RULE NO.: R161-23.24

NOTICE OF RULE ADOPTION

R161-23.24: Proposed revision to Standard 511-AW-02

Rule 2 – Revisions to Standard Detail 511-AW-02

STANDARD NO.
511-AW-02
1 OF 3

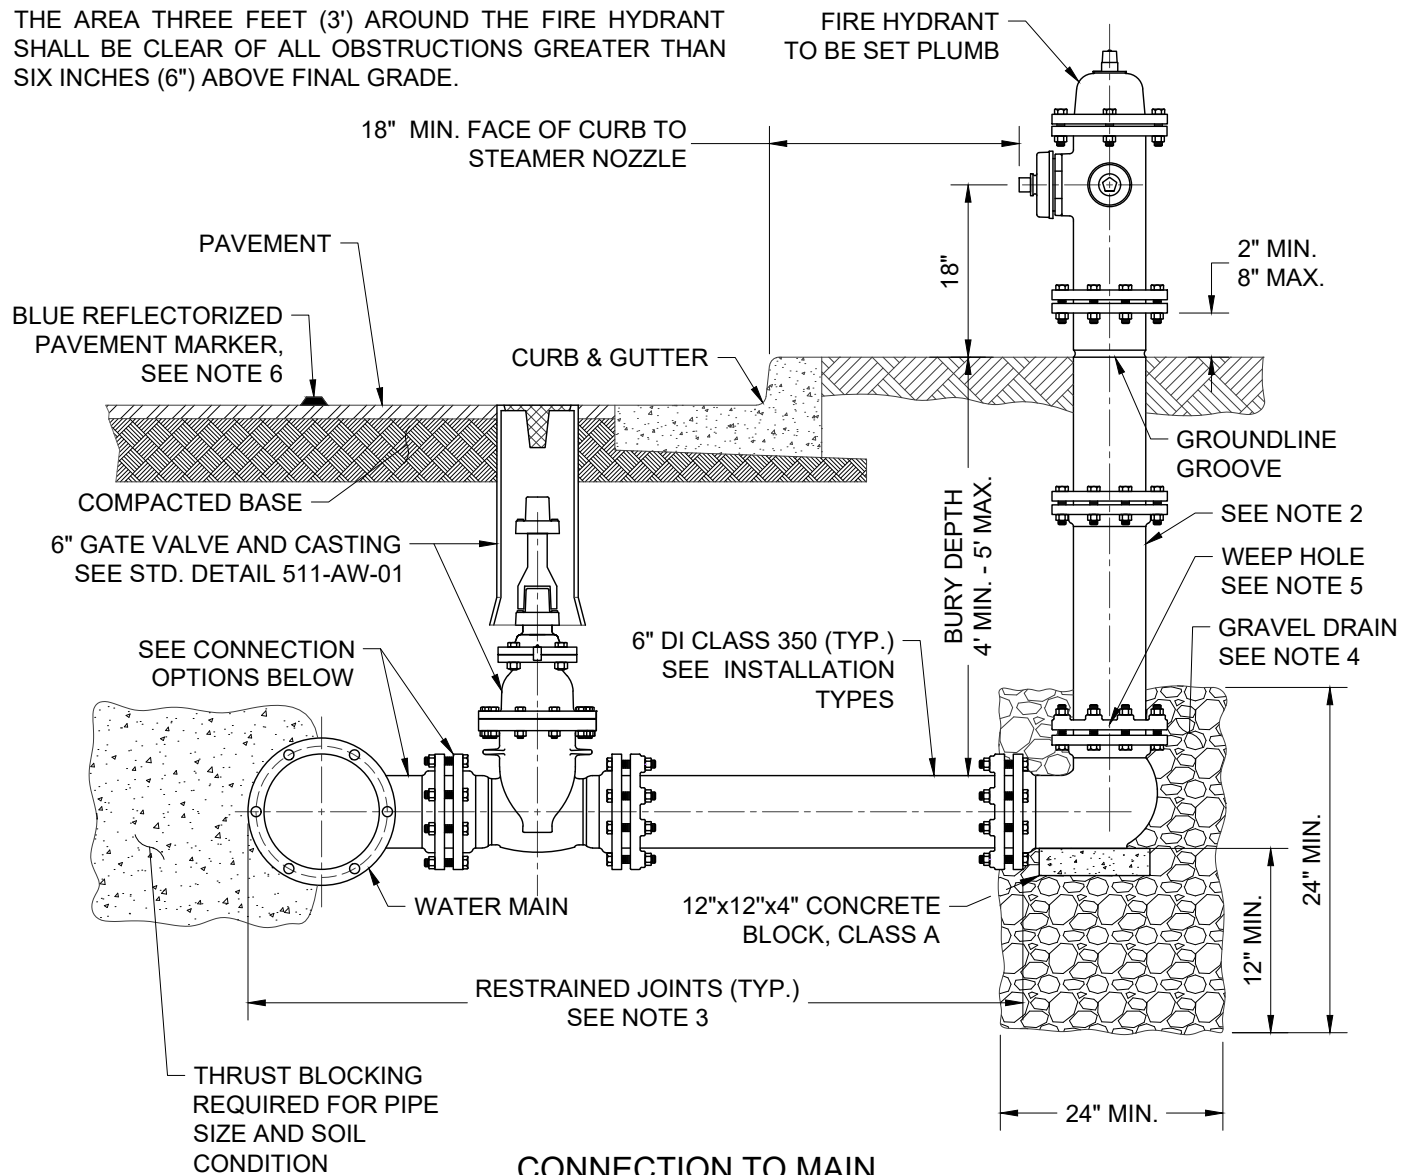
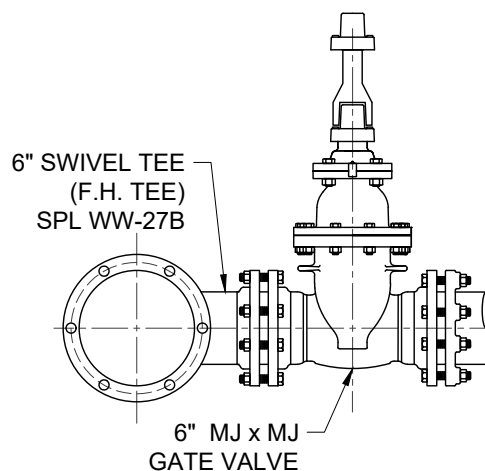
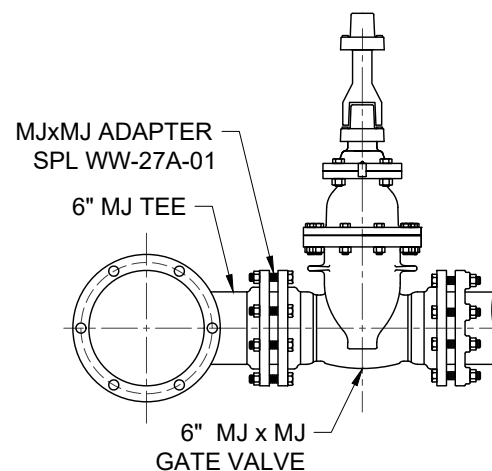
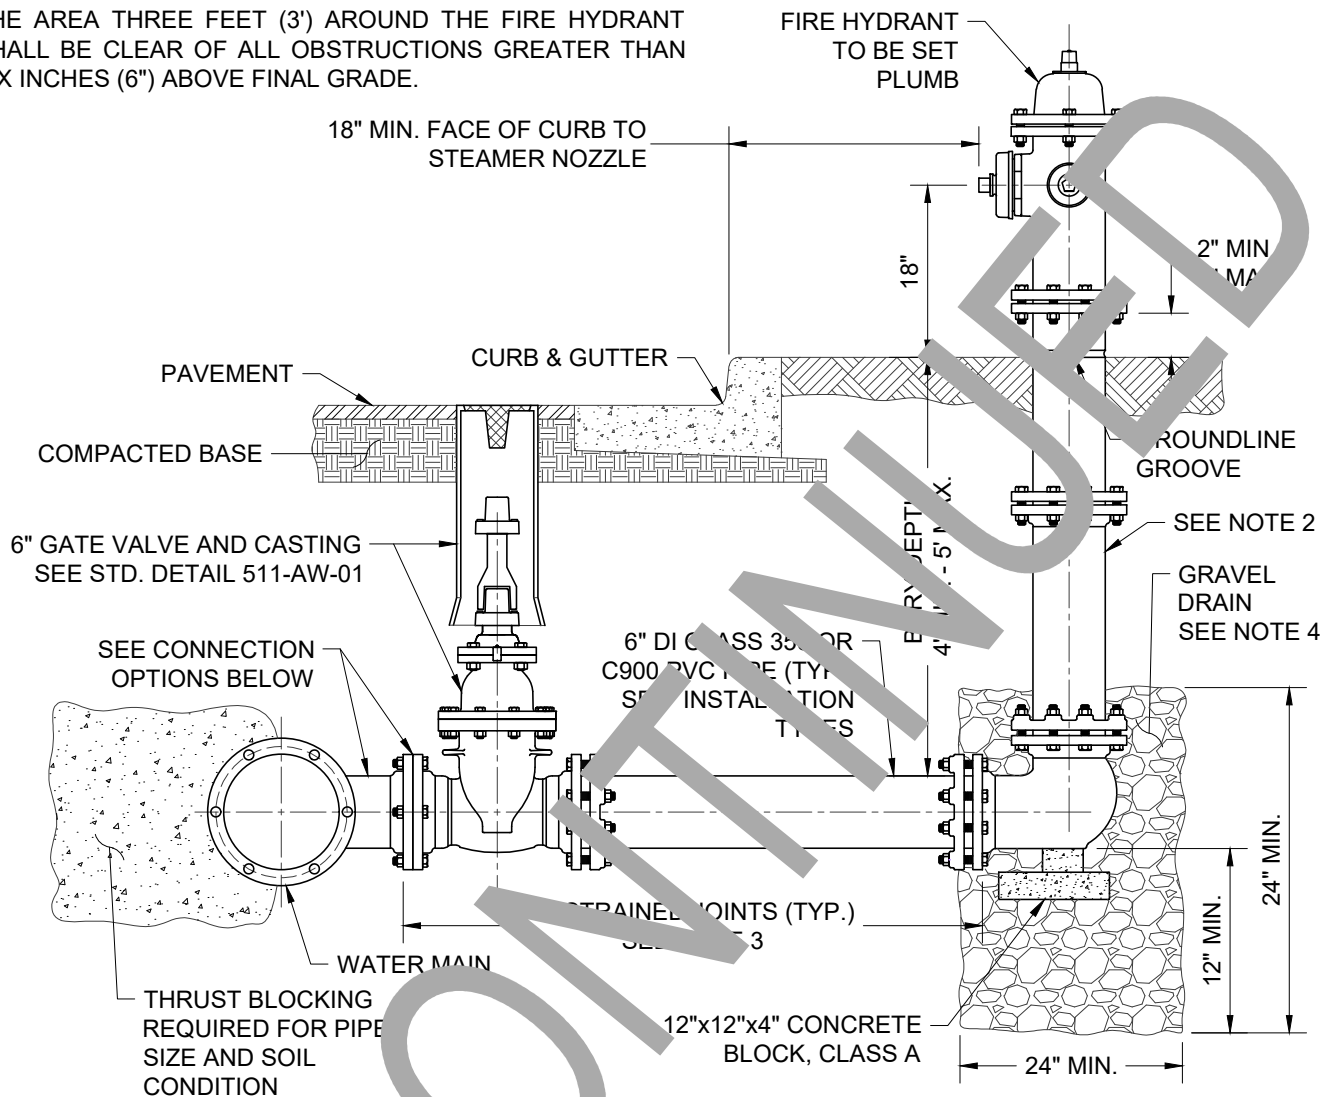
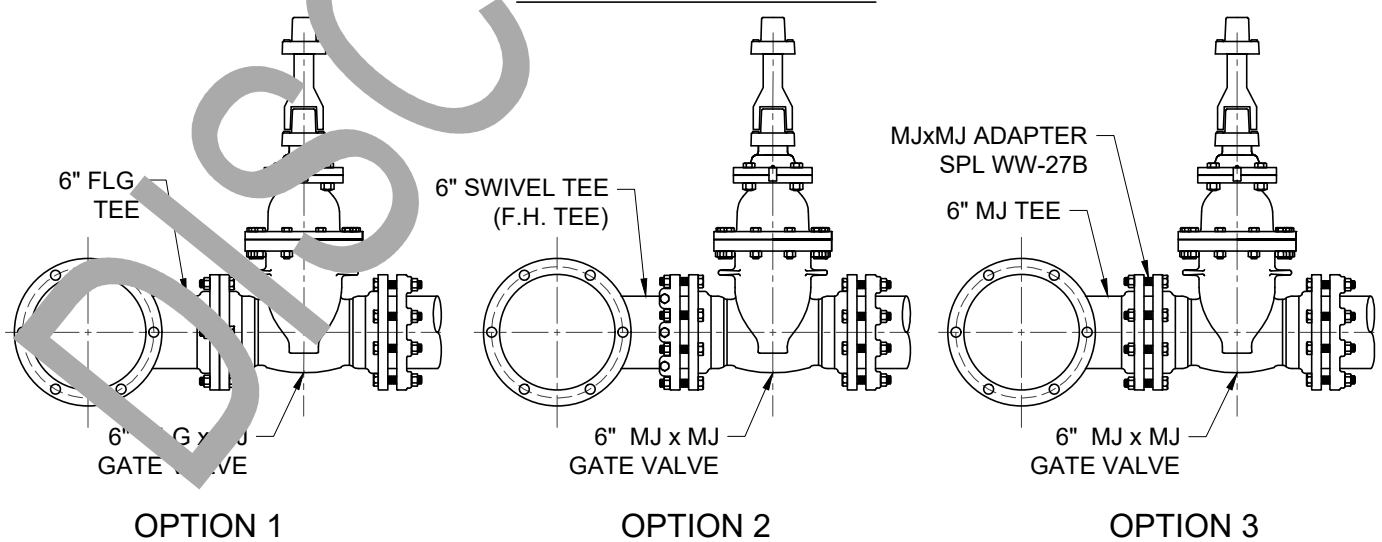
1. **Standard 511-AW-02** – We are updating this Standard to remove the PRV requirement and remove the allowance of PVC C-900, among other minor changes.
